UNITED STATES DEPARTMENT OF COMMERCE  
Patent and Trademark Office

# Office Action Summary

09/537,274

MOSLEY, LARRY EUGENE

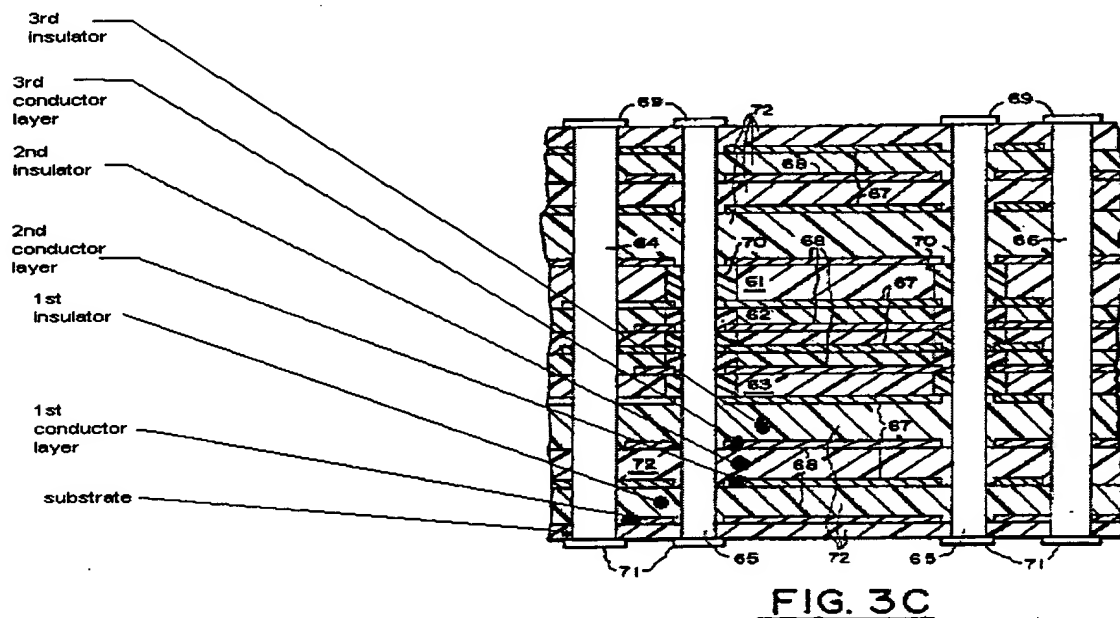
Claims 1, 2, 14-16, & 19, are rejected under 35 U.S.C. 102(e) as being anticipated by Farooq et al (US 6,072,690).

Regarding claim 1, Farooq et al. disclose in fig. 3C, a multilayer integrated circuit capacitor comprising: a substrate<sup>1</sup> (72); a first conductive layer (68) located over the substrate; a first insulator layer (72) located over the first conductive layer; a second conductive layer (67) located over the first insulator layer; a second insulator layer (72) located over the second conductive layer; a third conductive layer (68) located over the second insulator layer; a third insulator layer (72) located over the third conductor layer; and a plurality of conductive vias (64, 66) downwardly extending through the third insulator layer to provide electrical interconnection to the first, second and third conductor layers.

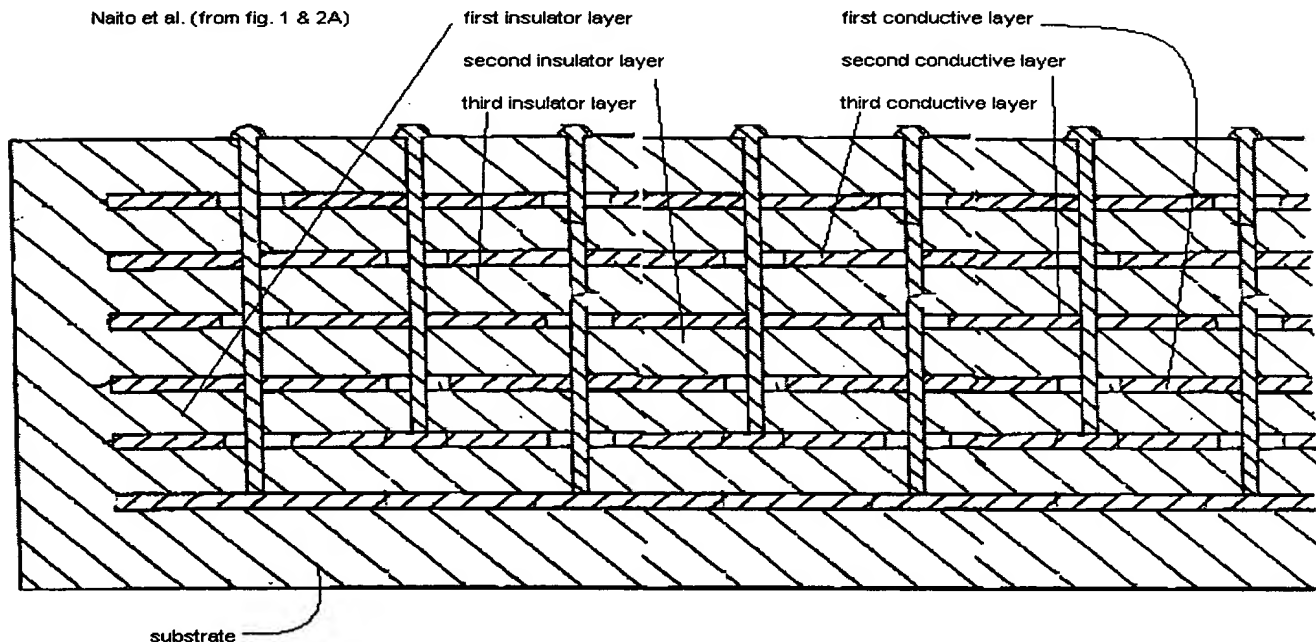
(72) located over the third conductor layer; and a plurality of conductive vias (64, 66) downwardly extending through the third insulator layer to provide electrical interconnection to the first, second and third conductor layers.

Regarding claim 19, Farooq et al. disclose in fig. 3C, a multi layer integrated circuit capacitor comprising: a substrate (72); a first conductive layer (68) located over the substrate; a first insulator layer (72) located over the first conductive layer; a second conductive layer (67) located over the first insulator layer; a second insulator layer (72) located over the second conductive layer; a third conductive layer (68) located over the second insulator layer; a third insulator layer (72) located over the third conductive layer; and a plurality of conductive vias (64, 66) downwardly extending through the third insulator layer to provide electrical interconnection to the first, second and third conductive layers, the plurality of conductive vias further extending through the substrate to provide electrical interconnects on both a top and a bottom surface of the integrated circuit capacitor.

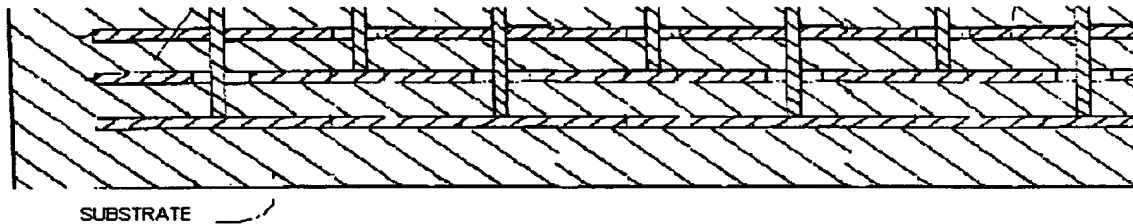
A) The argument "in the Office action, it is also asserted that Naito et al. discloses a substrate. However, Fig. 1 of Naito et al. only recites and illustrates element 32, described as a dielectric material layer". Such a continuous dielectric layer is not the same as a substrate, upon which dielectric material and conductive material maybe formed" is not persuasive. Naito et al. clearly illustrates an underlying layer (substrate see fig. below)
